Re: **Tronox LLC (TRX)**  
**NDEP Facility ID #H-000539**  
Nevada Division of Environmental Protection (NDEP) Response to:  
*Phase B Source Area Investigation Work Plan Area II (Central LOUs). Tronox LLC*  
*Facility, Henderson, Nevada*  
Dated June 27, 2008

The NDEP has received and reviewed TRX's Phase B, Area III Sampling Analysis Plan (SAP) identified above and finds the document acceptable with the conditions and comments provided in Attachment A.

### Attachment A

| SAMPLE LOCATIONS FOR LOU #31 DRUM RECYCLING AREA                                  |           |                 |

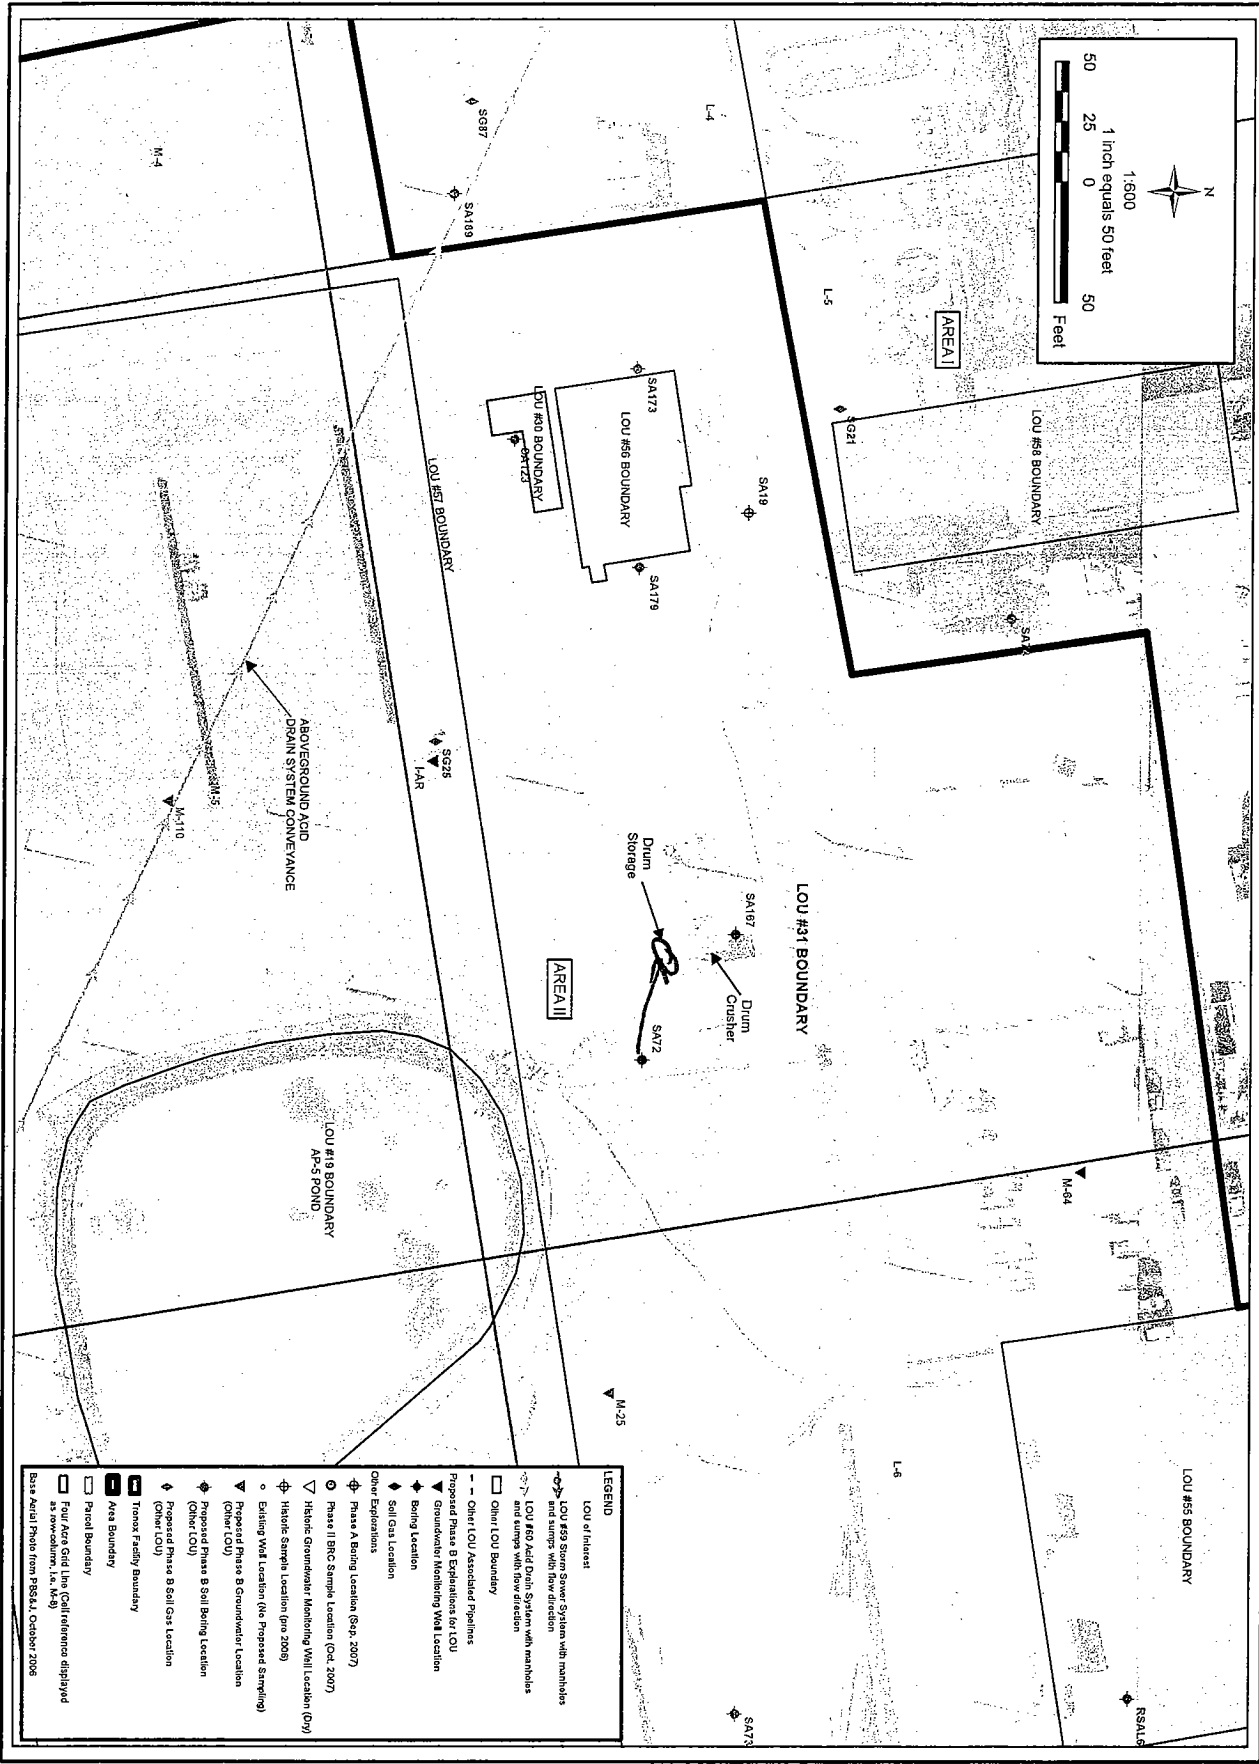
- g. LOU 31 (Drum Recycling Area), SA72 should be moved to a location in the former drum storage area. (Please see the corresponding attached figure as necessary.)

• MOVE SAT22 to Drum Storage Area

| SAMPLE LOCATIONS FOR LOU #59<br>STORM SEWER SYSTEM SEGMENT IN AREA II             |           |                 |

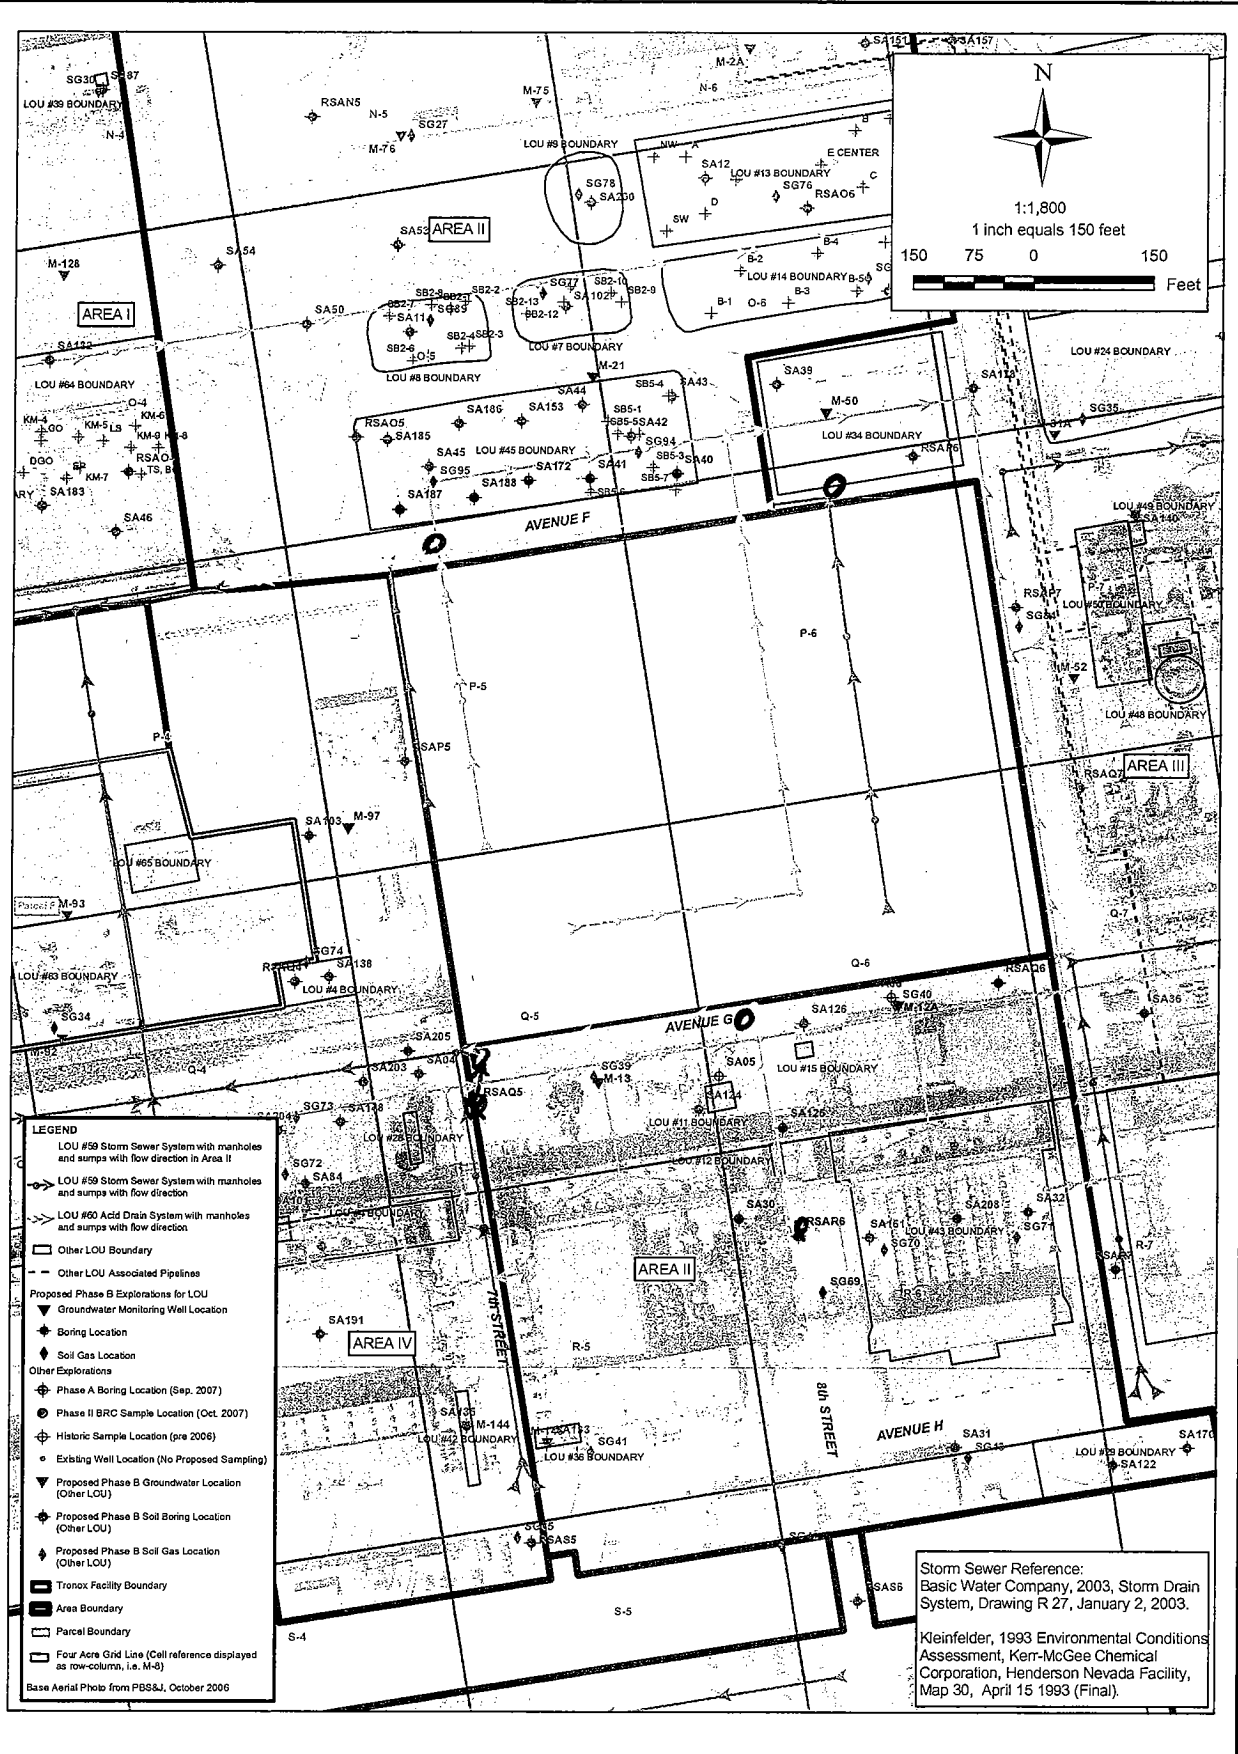
- i. General comment, the borings associated with this LOU should be located immediately adjacent to the storm drain system whenever possible.
  - ii. RSAQ5 should be moved north adjacent to LOU 59 in the vicinity of the southwest corner of ChemStar property.

- iii. RSAR6 should be moved north adjacent to LOU 59 and over LOU 60.
  - iv. An additional boring should be located adjacent to LOU 59 at the 90 degree turn just south of ChemStar property.

- v. An additional boring should be located adjacent to LOU 59 just north of ChemStar property, south of LOU 45 and over LOU 60.
  - vi. An additional boring should be located adjacent to LOU 59 just south of LOU 34 at the 90 degree turn just north of ChemStar property.

additional boring  
 additional boring  
 additional boring  
 North of ChemStar, south of Lou 45, over Lou 60  
 North of ChemStar, south of Lou 39, at 90° turn  
 South of ChemStar, at 90° turn  
 adjacent to Lou 59  
 move R5 & B6 over Lou 60
